UNITED STATES PATENT AND TRADEMARK OFFICE

APPLICATION NO.	FILING DATE	FIRST NAMED INVENTOR	ATTORNEY DOCKET NO.	CONFIRMATION NO.
10/730,021	12/09/2003	Andreas Obrebski	0902-009	2756

Office Action Summary

DETAILED ACTION

Fig. 1

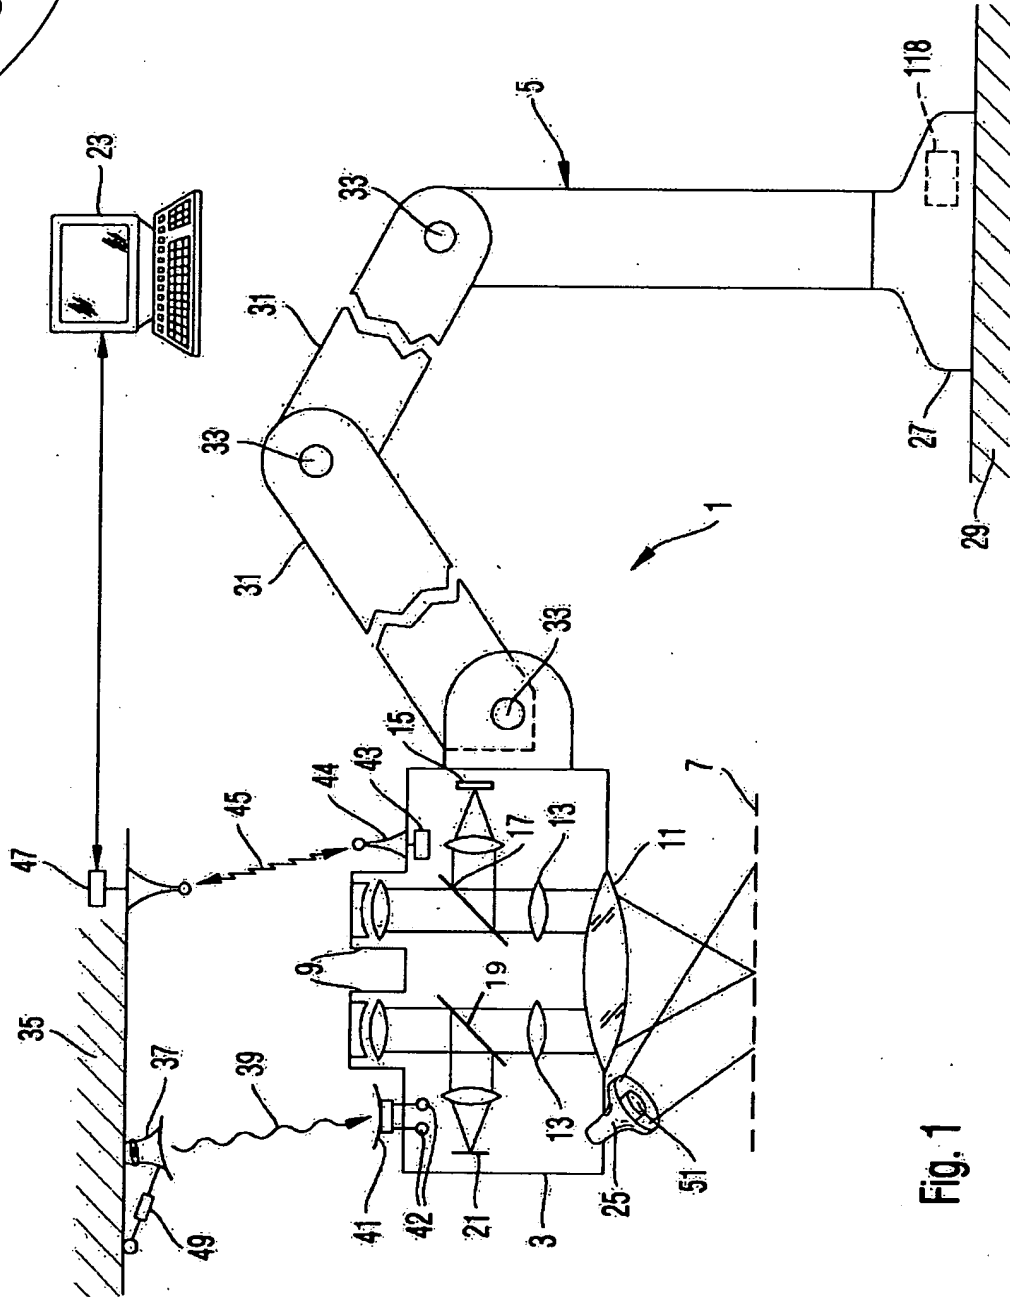
2. The replacement sheet contains corrected figure 1 was received on 8/7/2006. The replacement sheet having corrected figure 1 is approved by the Examiner.

Entirety approved
10/13/06
